Extruded Polystyrene Insulation
FOAMULAR[®]

Project: CHESTERTON H.S.
SWIMMING POOL
CHESTERTON, INDIANA

Scale: 1/16" = 1'00" Drawn: T.L.I.
Slope: VARIES Checked: R.E.G.
Date: 5/14/98 T-21897C

Drawing number: 4 of 7

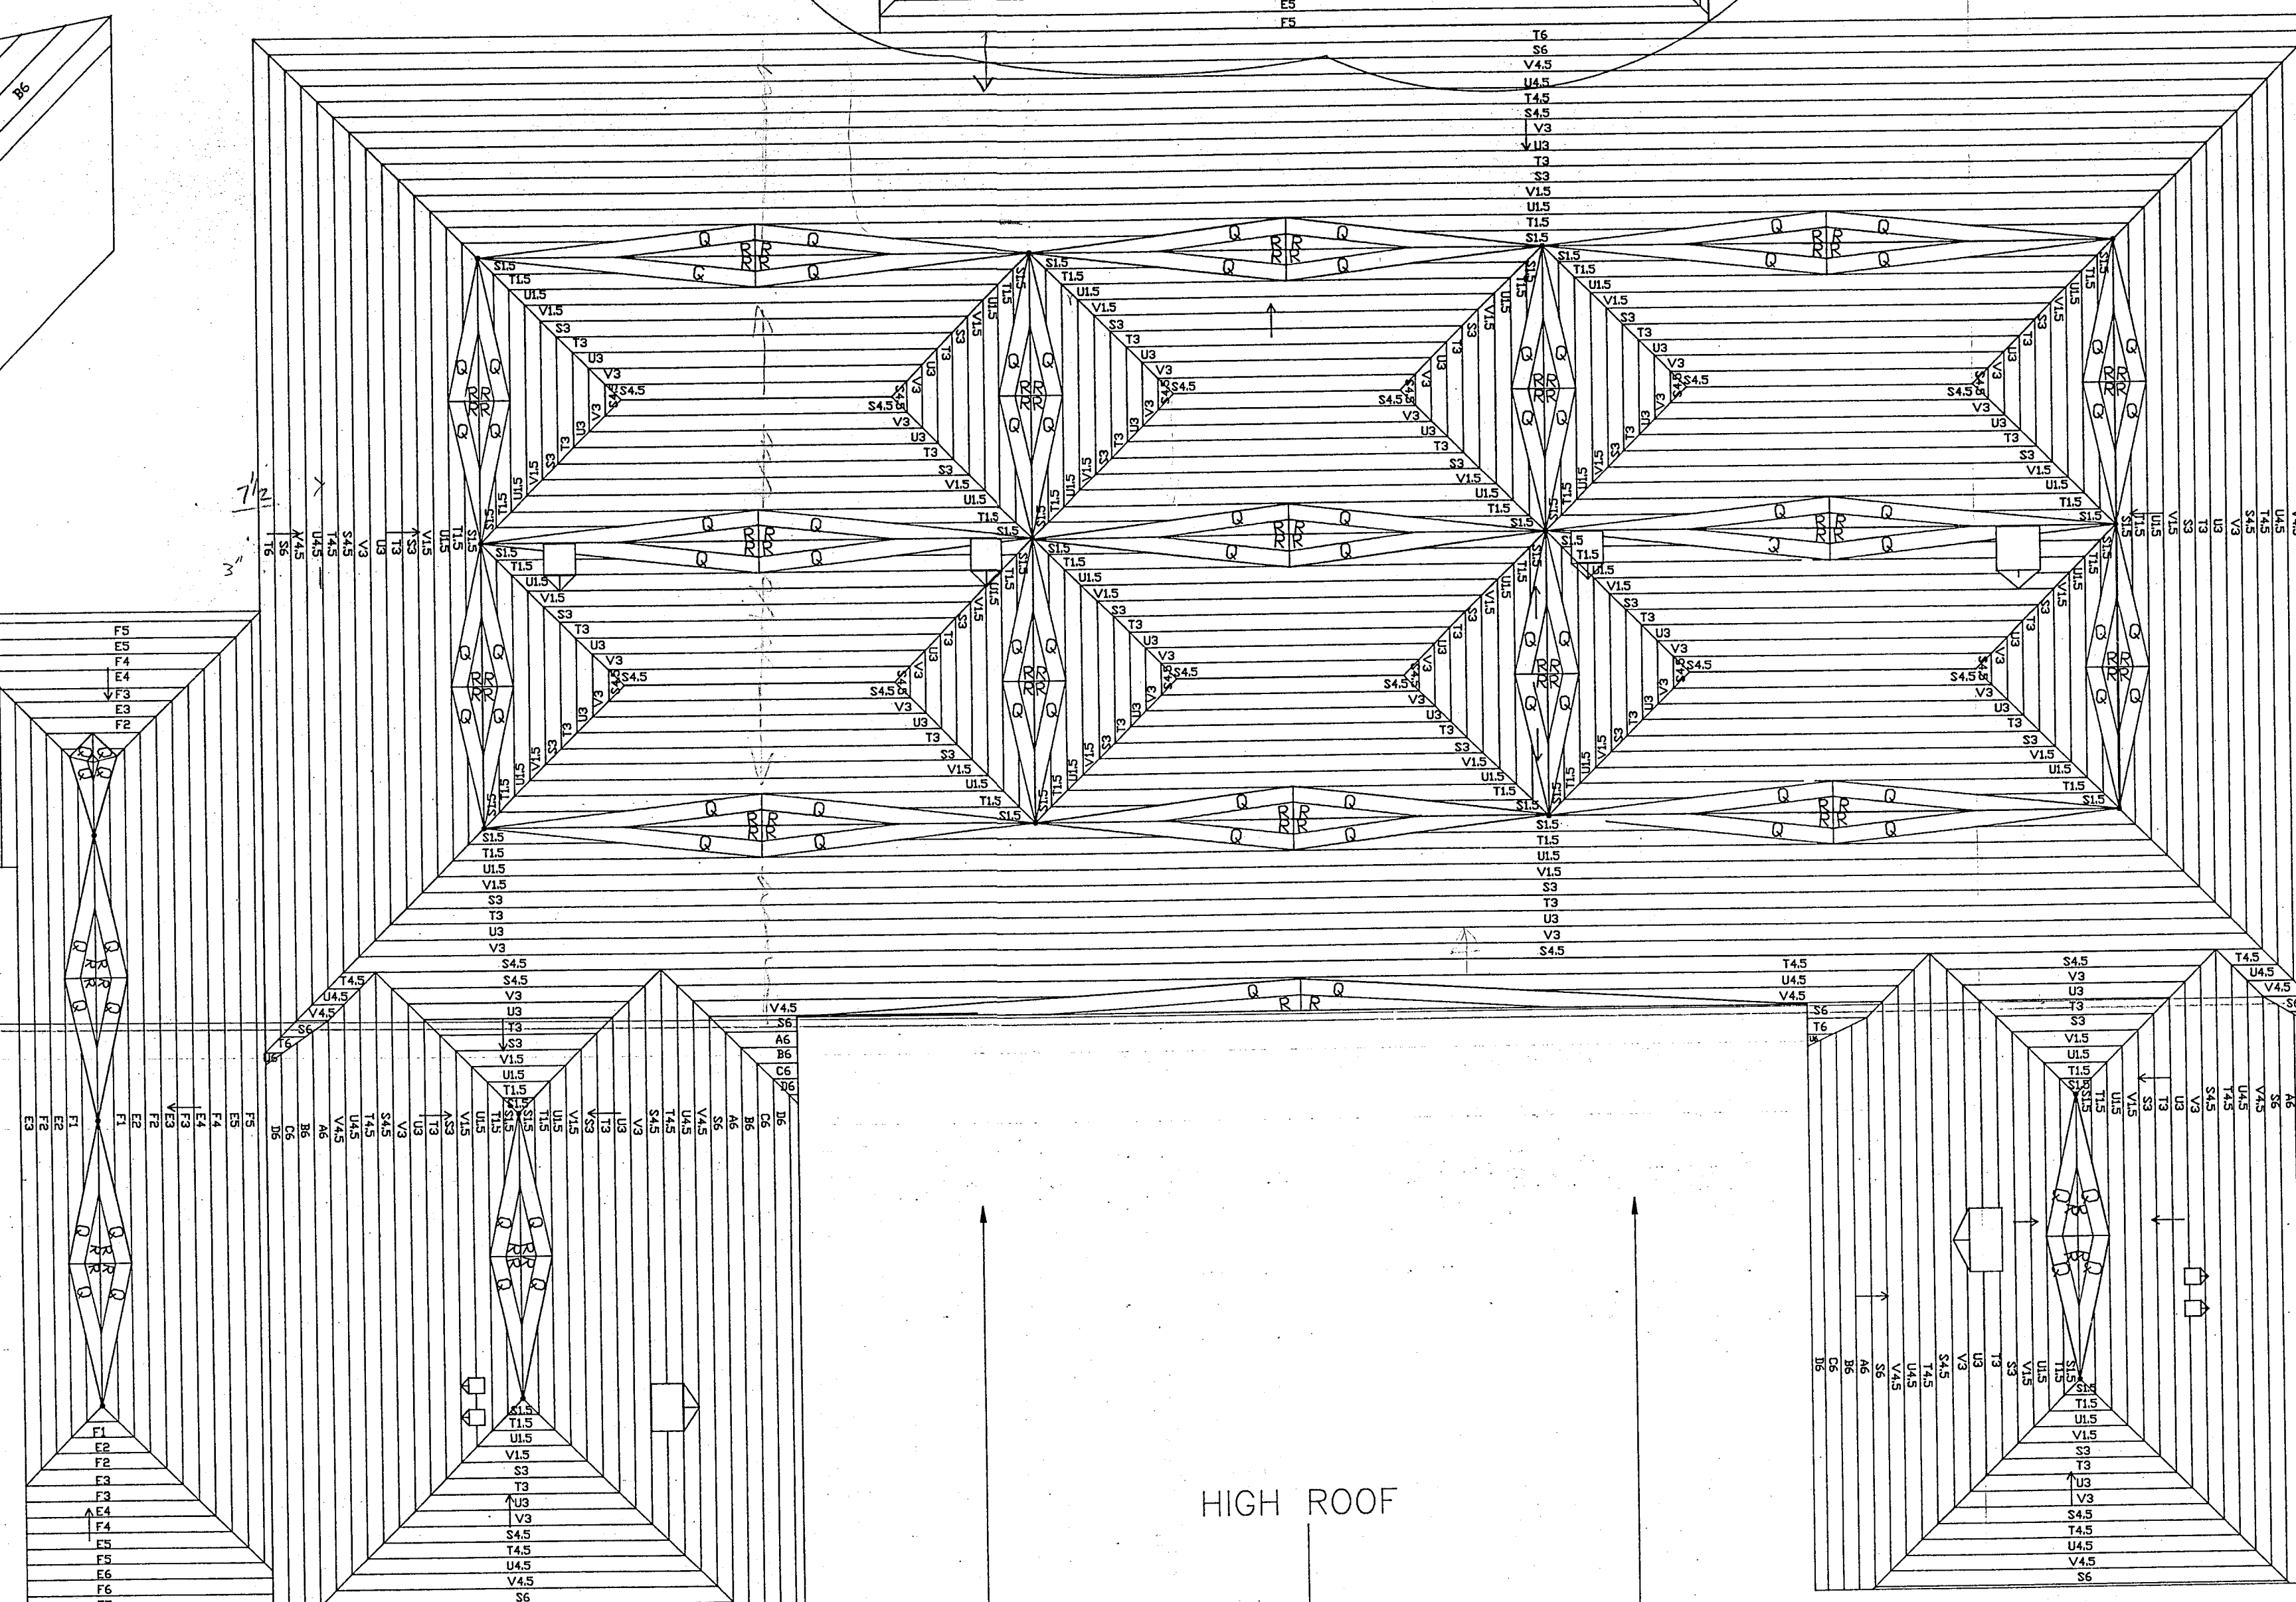
1. REVISED DRAWING FOR RELOCATION OF ROOF DRAINS PER W. R. KELSO.
2. CHANGED TAPER LAYOUT, SADDLE SLOPE THICKNESS PER FANNING & HOWEY 2/6/98
3. ADDED DRAINS & CHANGED SLOPES 4/14/98
4. CHANGED SLOPES IN VARIOUS ROOF AREAS AND MOVED DRAINS. 5/14/98
